11" Pull Out App Option Divider App

STATUS
05
11" Pull Out App Option Divider App
546.31.800

RevNo	Project # or change Request #	Date	Signature	Checked
001	File updated	12.01.2011	NPG	RM

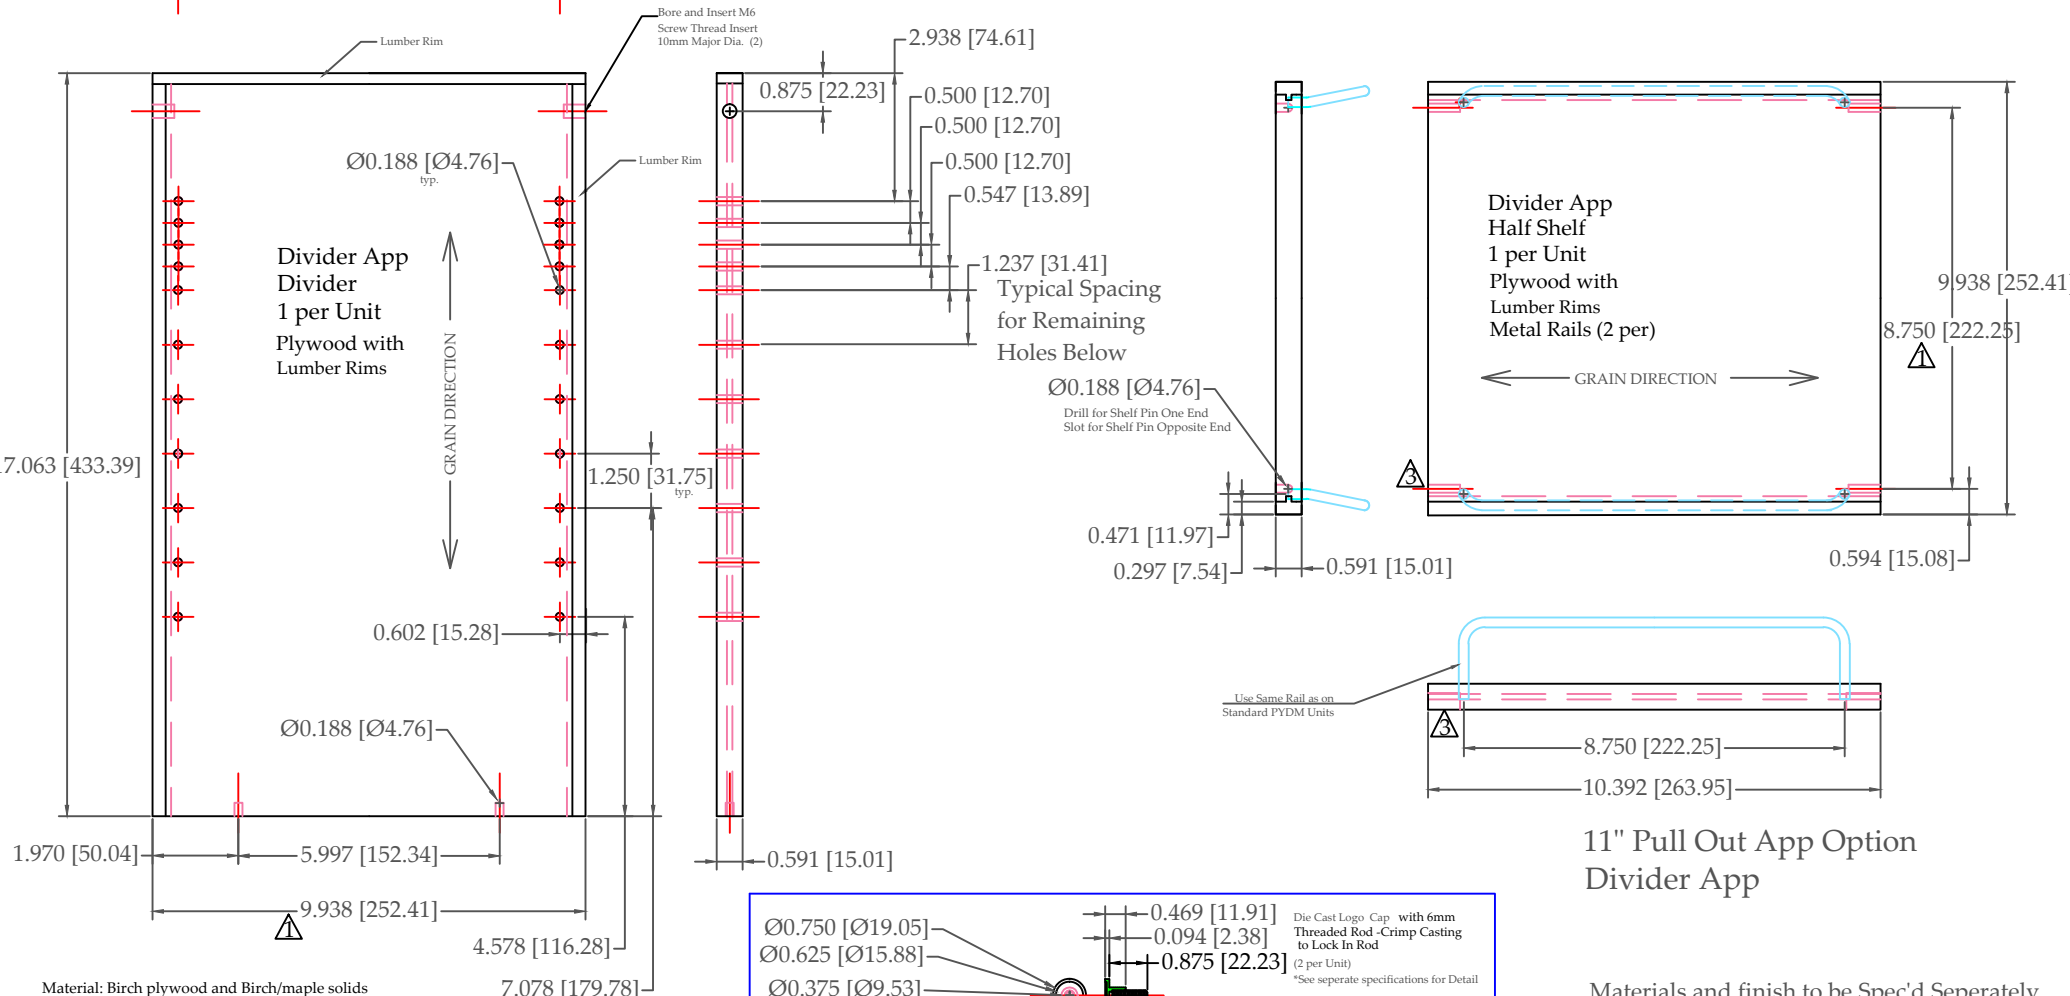
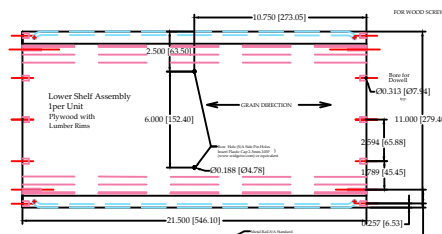
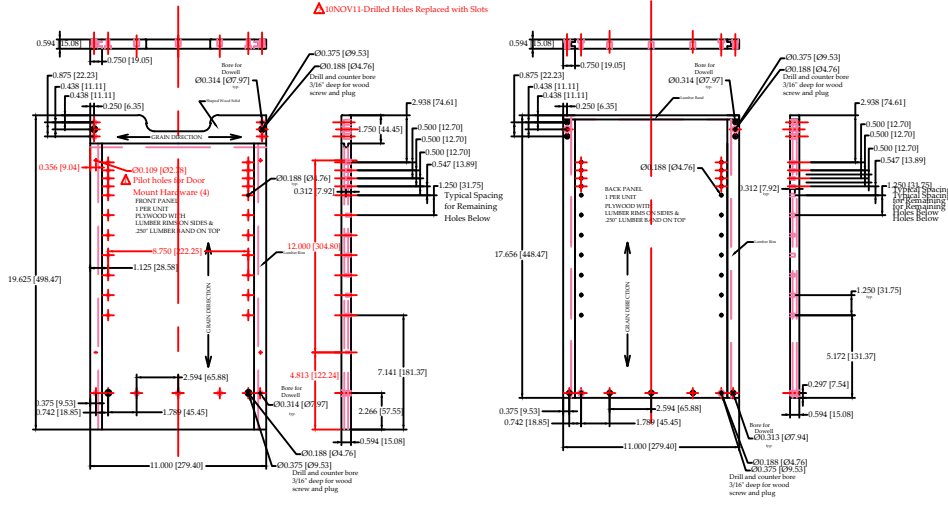
- Materials and finish to be Spec'd Separately
- ⚠ 11NOV11-Vertical Divider and Demi-shelf width changed to 9 15/16"
- ⚠ 11NOV11-6pc. 2" shelf pins added
- ⚠ 11NOV11-Drilled Holes Replaced with Slots

Ø0.750 [Ø19.05] — Die Cast Logo Cap with 6mm Threaded Rod - Crimp Casting to Lock In Rod (2 per Unit)
 Ø0.625 [Ø15.88] — *See separate specifications for Detail
 Ø0.375 [Ø9.53] — *Include 6 pc. 2" metal shelf pin-match diameter of std. pins
 2.000 [50.80] —

11in Pullout Unit-Basic Components.REV.001

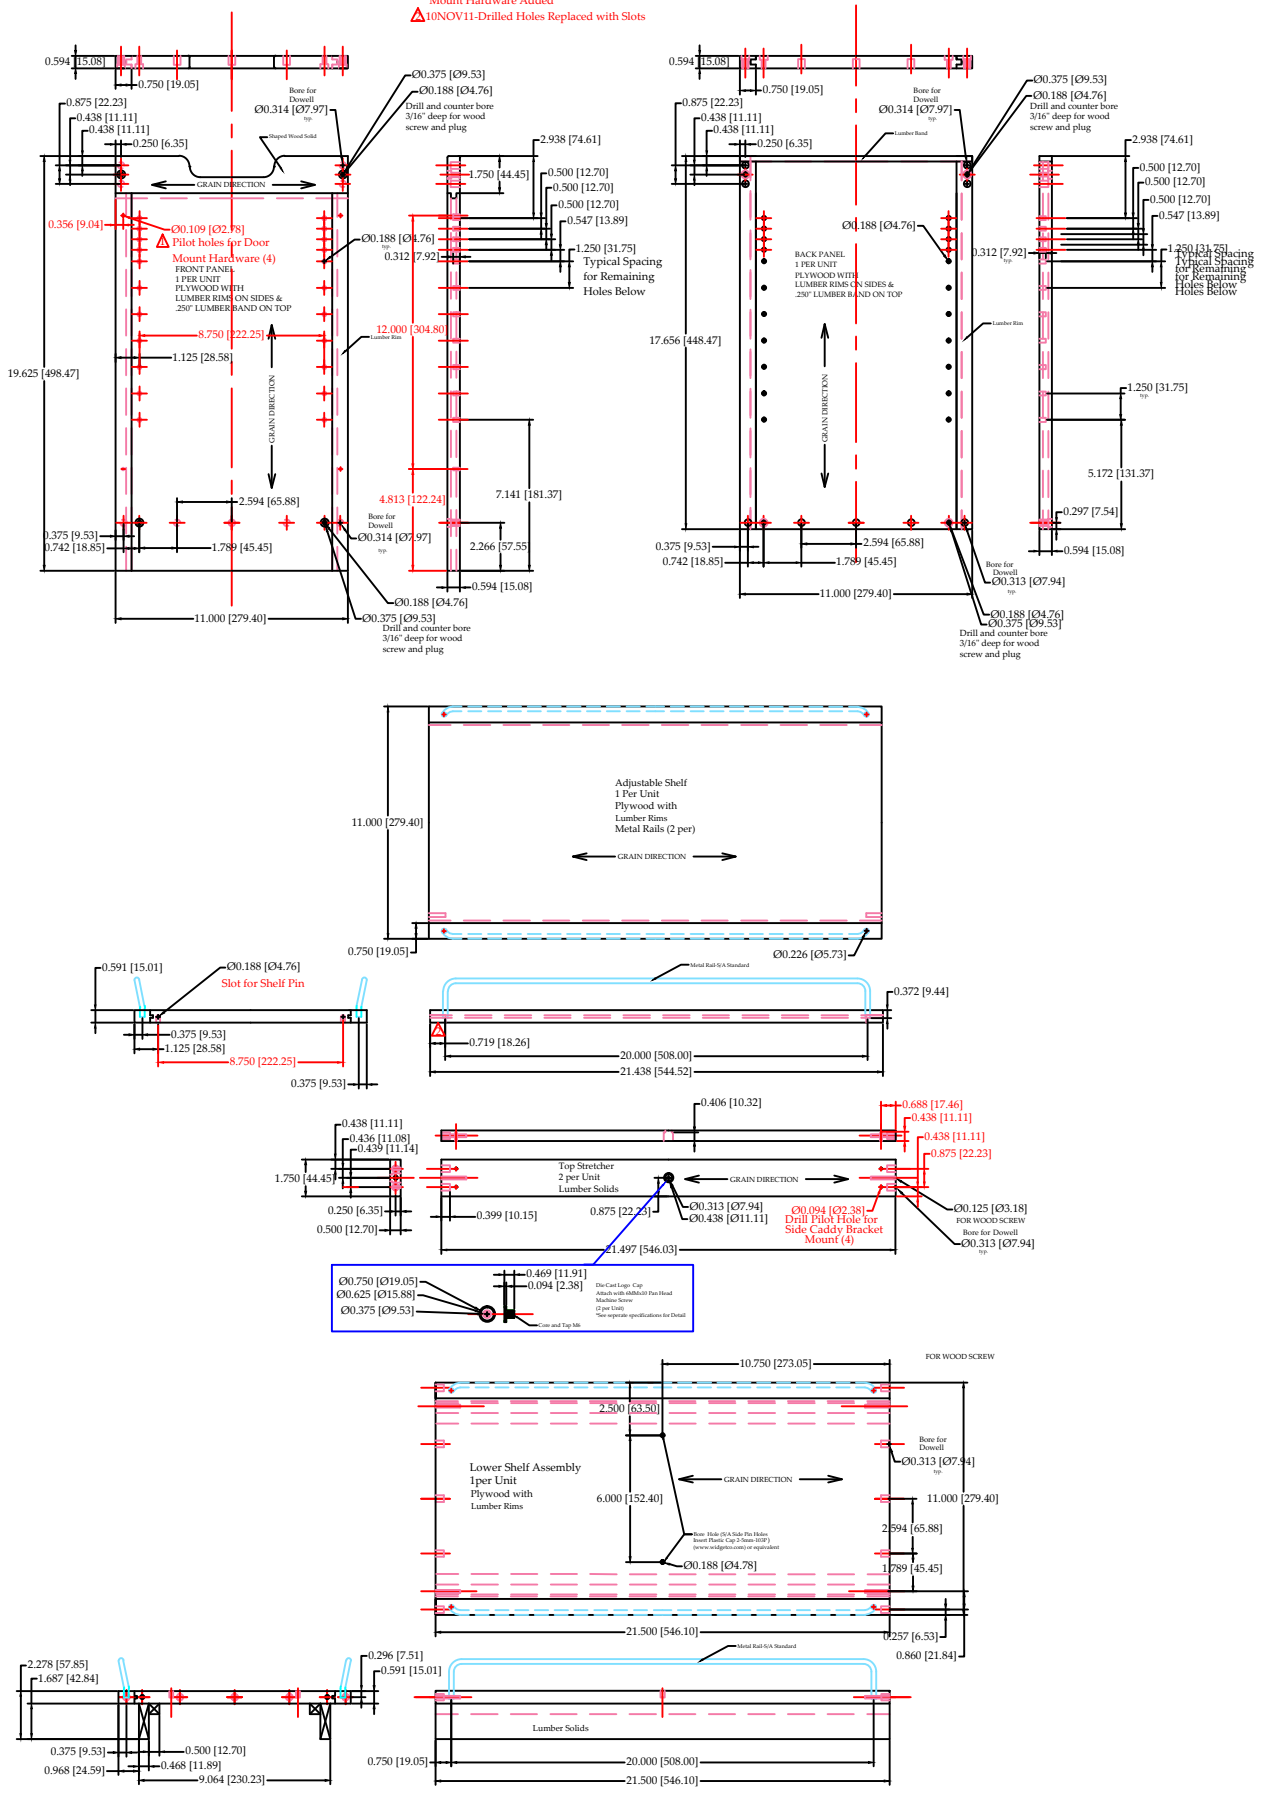
- ▲ 19OCT11-Pilot Holes for Door
Mount Hardware Added
- ▲ 10NOV11-Drilled Holes Replaced with Slots

11" Pull Out Vertical Divider

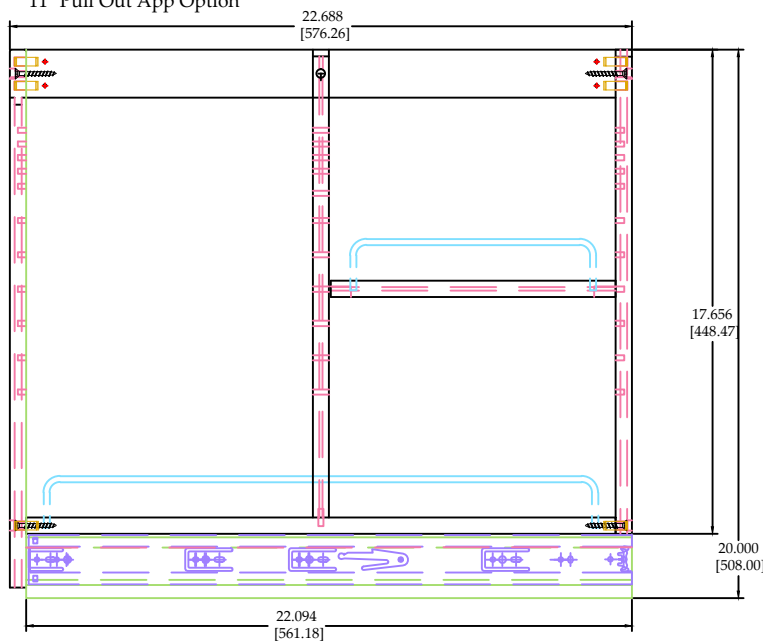
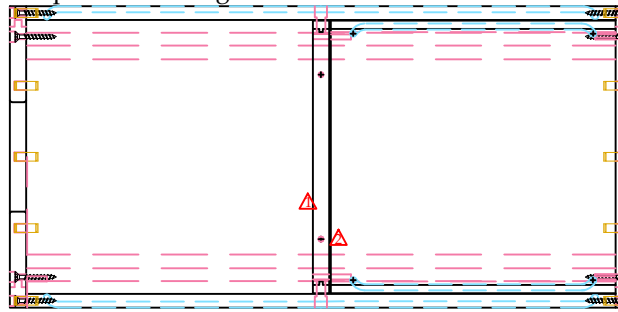
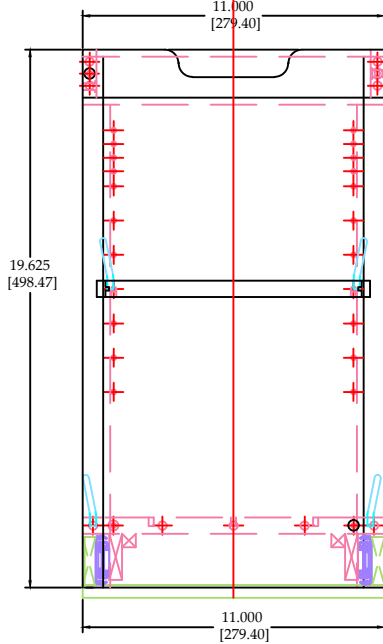
Materials and finish to be Spec'd Separately
 ▲ 11NOV11-Divider upright width changed to 9 15/16"
 ▲ 11NOV11-Demi Shelf width changed to 9 15/16"

11" Pull Out App Option Basic	546.31.800
-------------------------------	------------

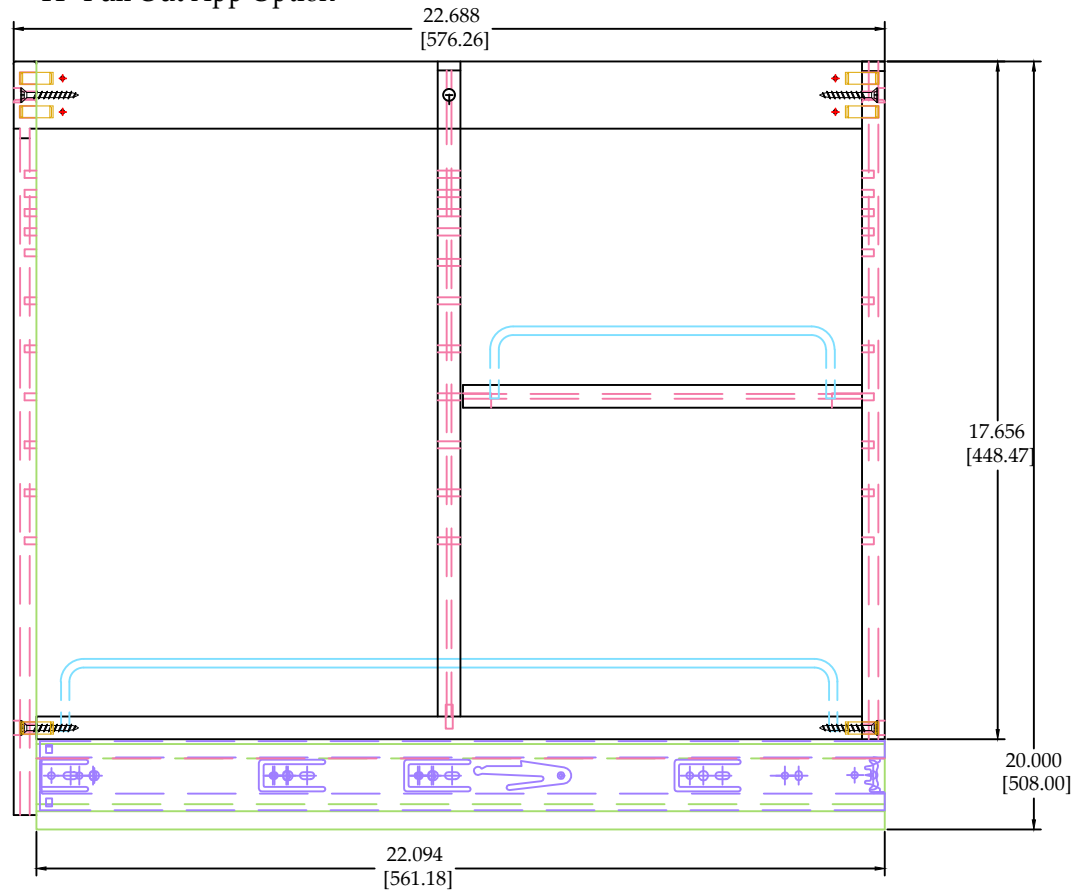
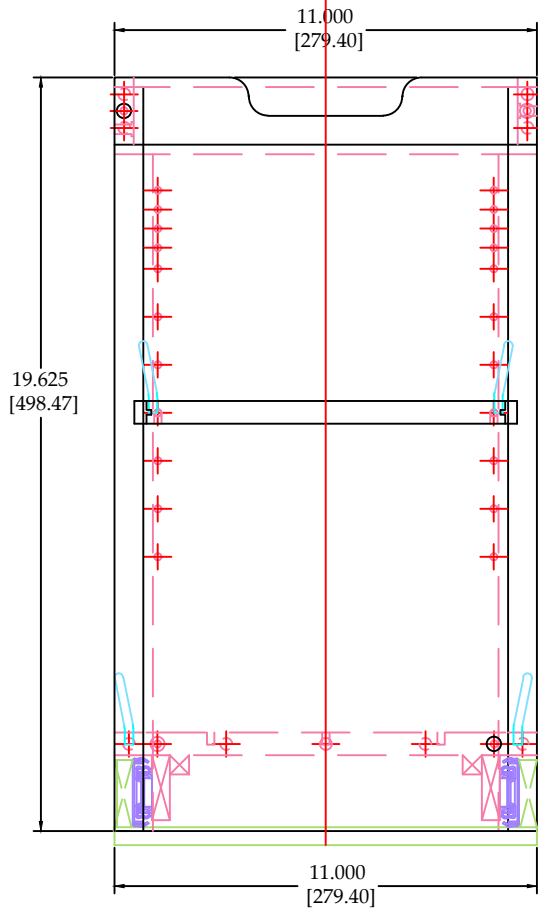
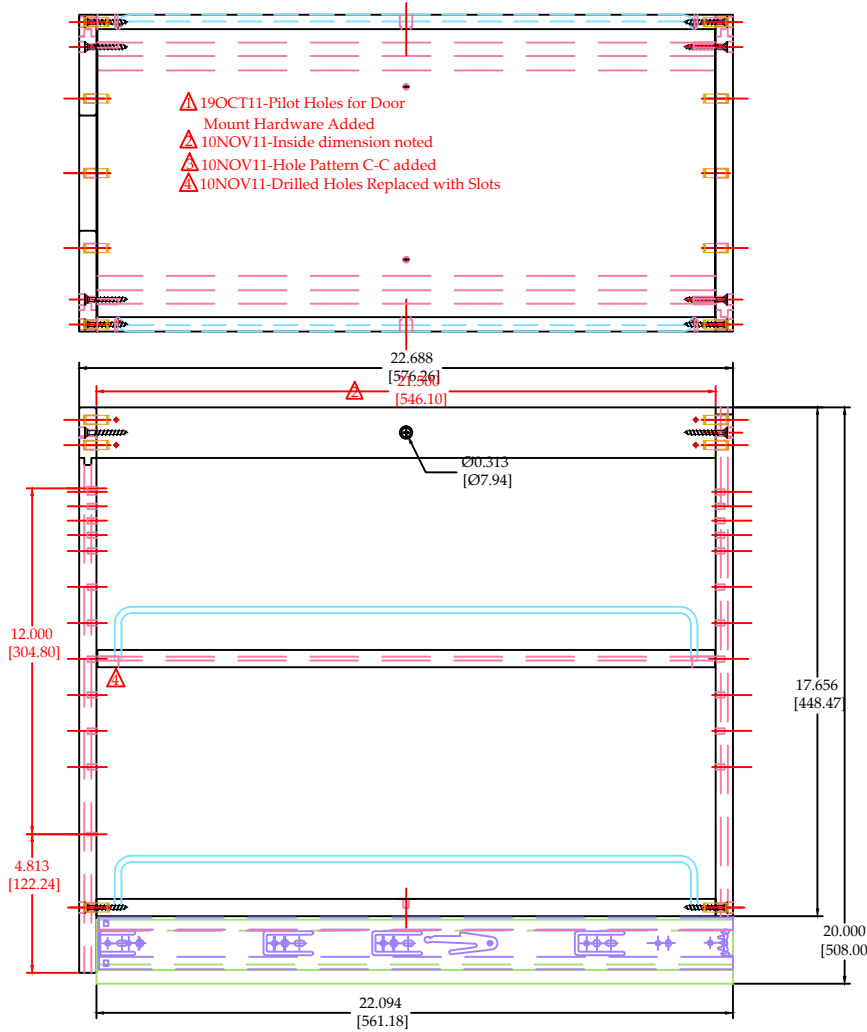
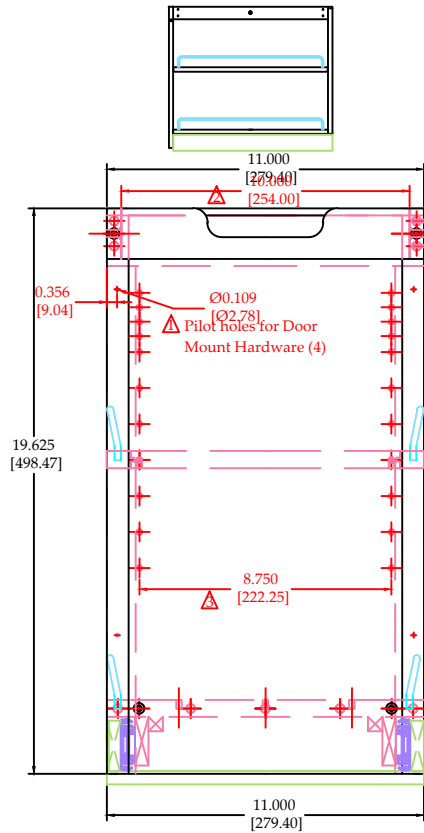
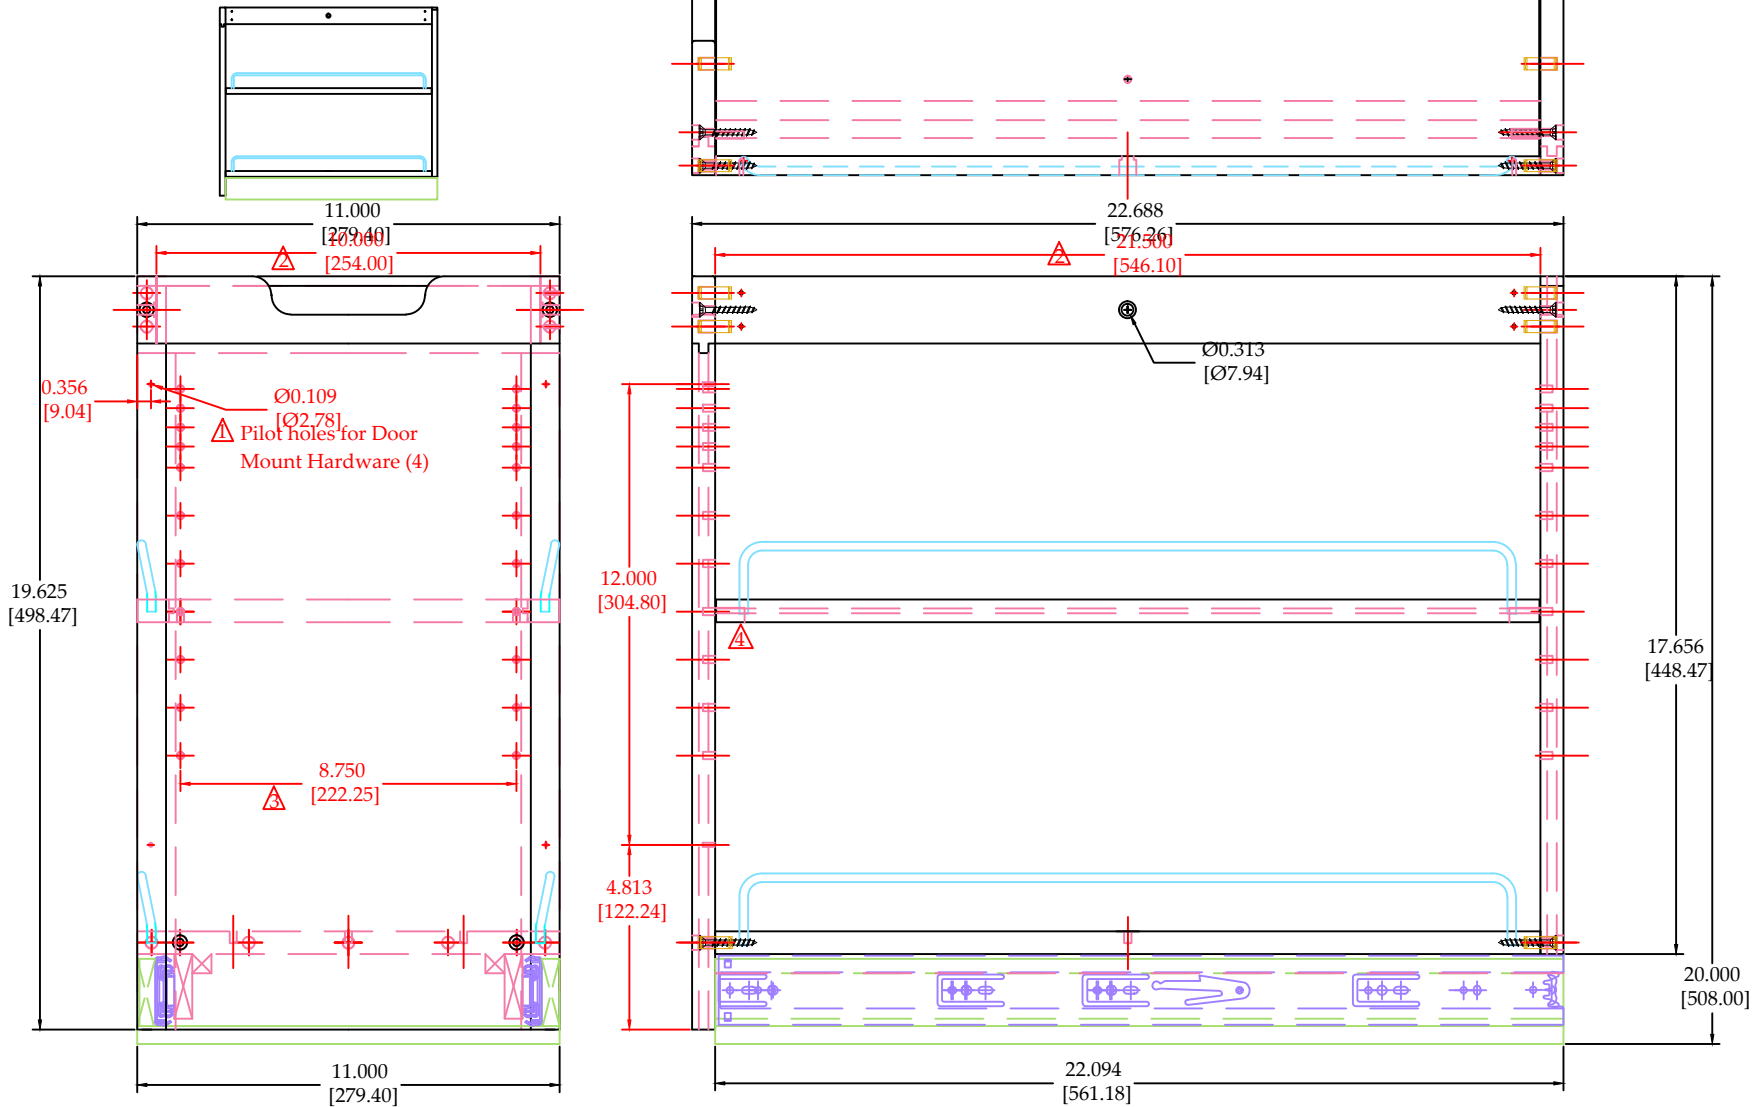
- ▲ 19OCT11-Pilot Holes for Door Mount Hardware Added
- ▲ 10NOV11-Inside dimension noted
- ▲ 10NOV11-Hole Pattern C-C added
- ▲ 10NOV11-Drilled Holes Replaced with Slots
